MMSE FOM: HH Calculation Speed up

COM Commit Request 4p16_2

Adam Gregory, Samtec

Hansel D'Silva, Amphenol

Device pkg model, class A with 12 mm
Device pkg model, class A with 33 mm
Device pkg model, class B with 30/ 29 mm
Device pkg model, class B with 45/ 44 mm

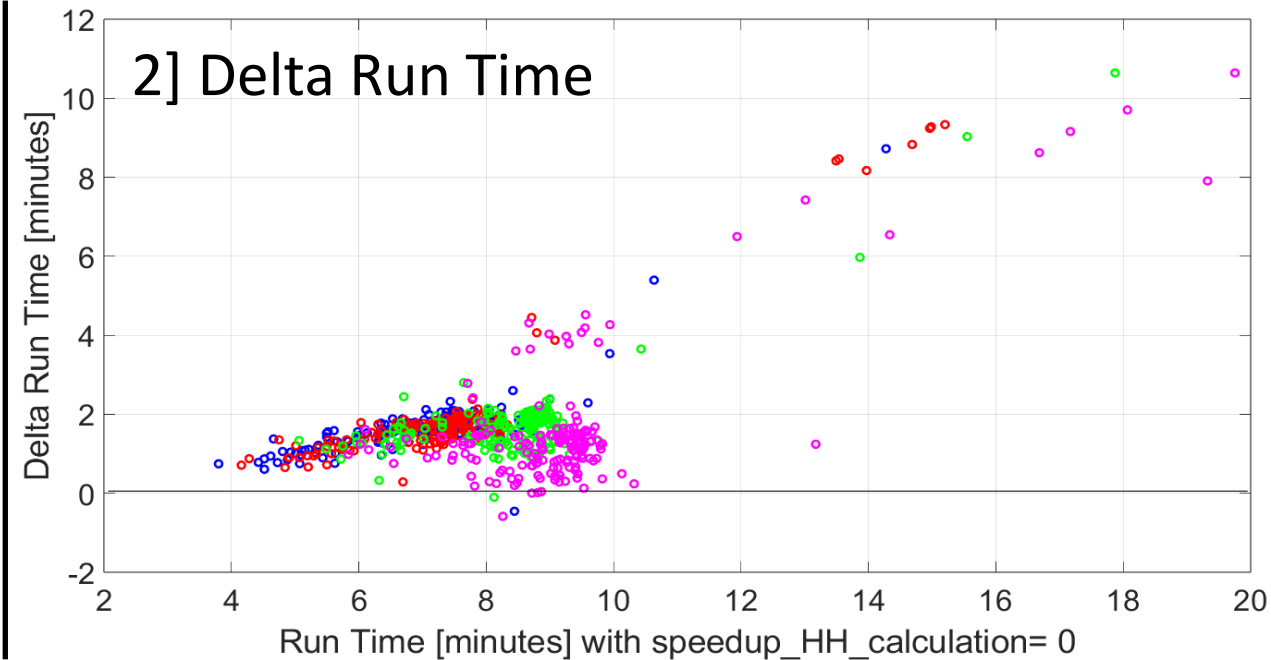
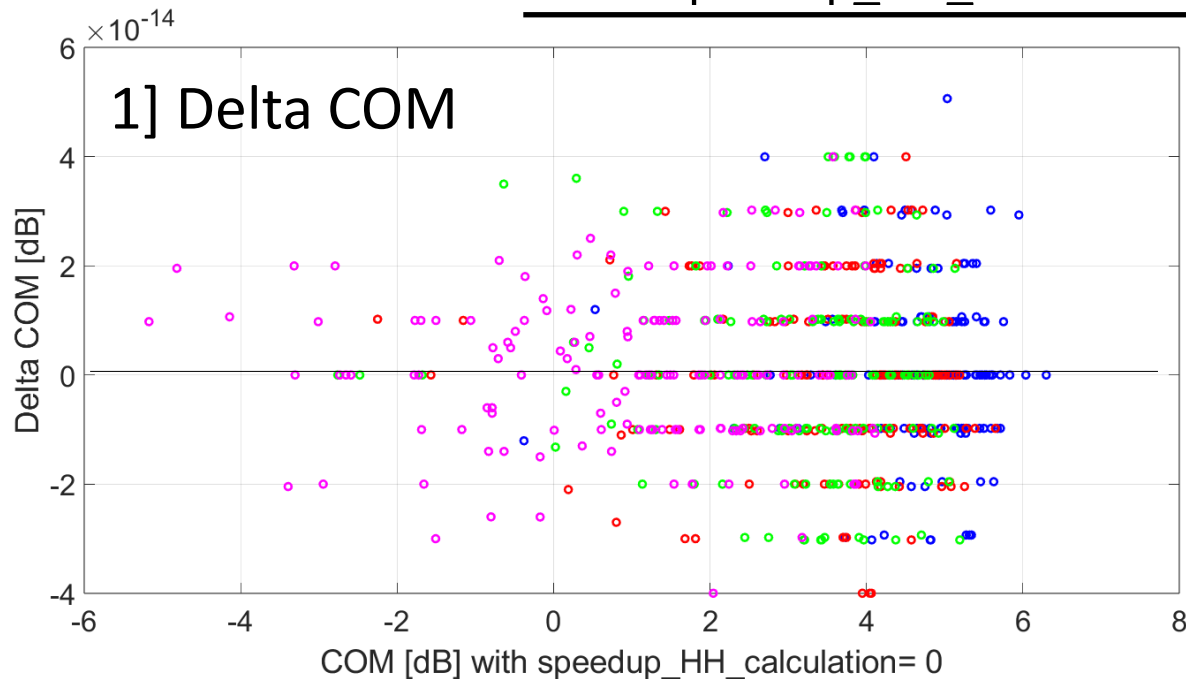
Delta= speedup_HH_calculation= 0 – speedup_HH_calculation= 1

- The new computation of HH has negligible impact (delta of 1e-14) on the value of COM.
- The new computation of HH has significant improvement (as much as 12 minutes) on the value of run time.
